User Safety Notice

30 ft. / 9 m. Workman® Self-Retracting Lanyard

October 28, 2015

Yellow Tamper Evident Paint

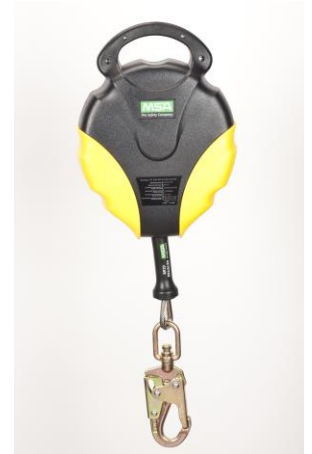
Please note that the replacement SRLs may also have a “date made” from 01-2015 through 08-2015, but include yellow tamper evident paint on the exterior housing screw heads near the handle, as shown in the photo below. These SRLs are new units that were factory upgraded to include a new brake assembly and are acceptable for use.
